SOILS AND GEOLOGY STUDY

**18885 Brown Road
Lots 1-3, Owl Ridge Subdivision
El Paso County, Colorado**

JOB NO. 185466

**November 15, 2021
Revised: February 21, 2022**

FIG-4

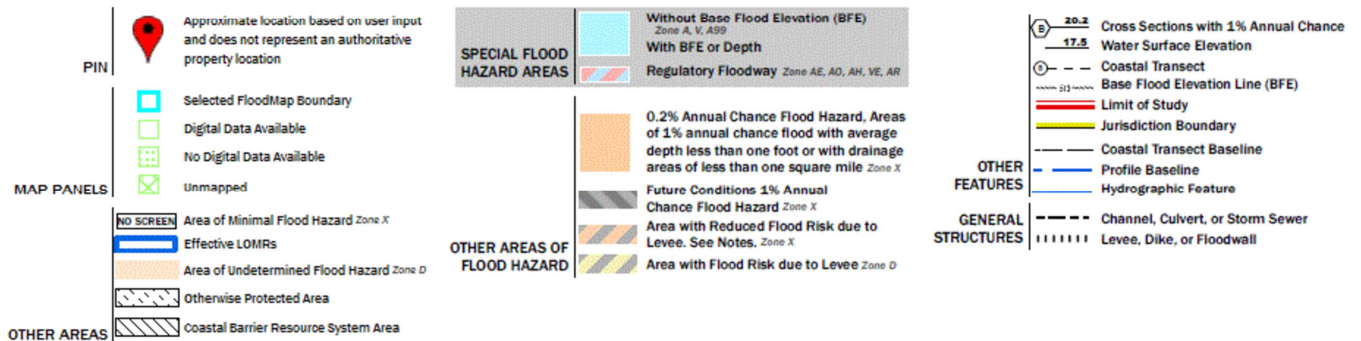
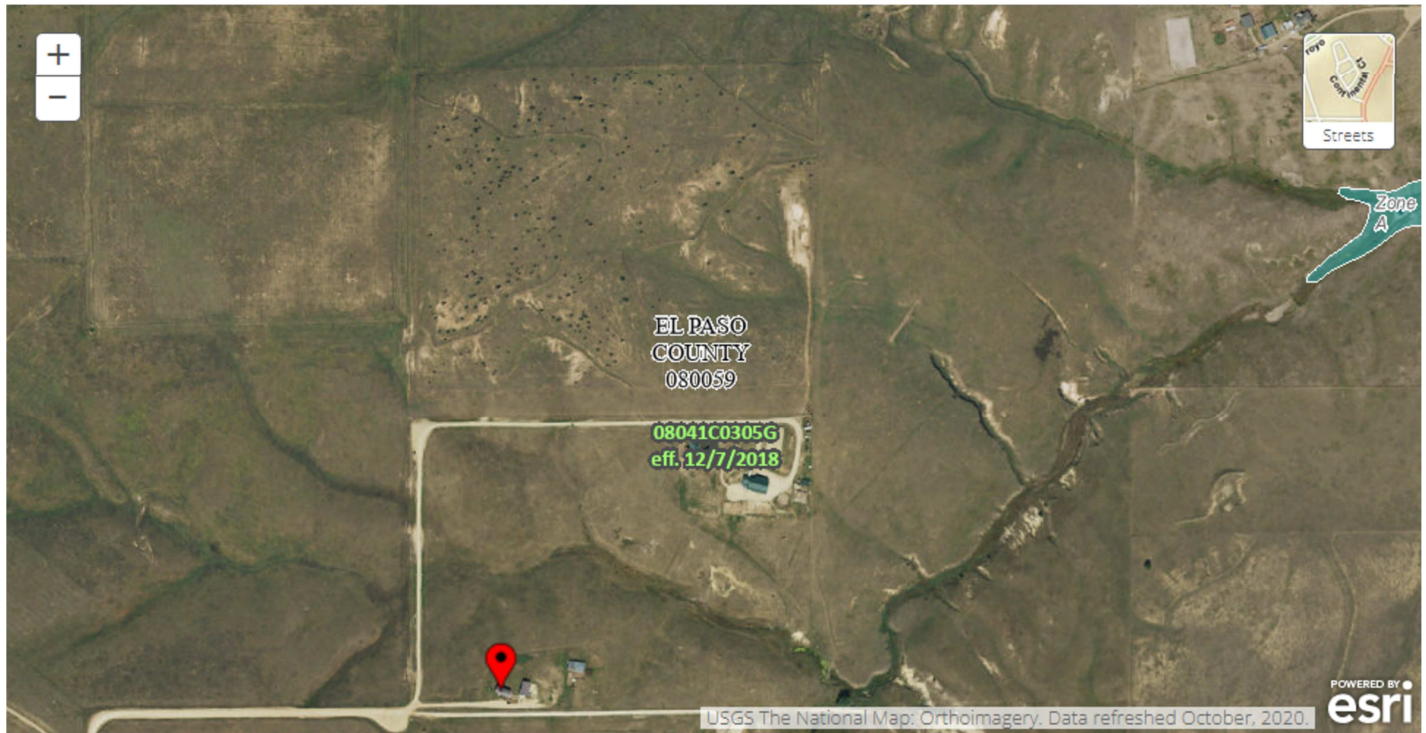
See CGS review comments to be addressed on seasonal wet areas on Fig 4 and expected seasonal groundwater fluctuations etc. The drainage report depicts a proposed building site potentially directly in the area shown as season wet area.
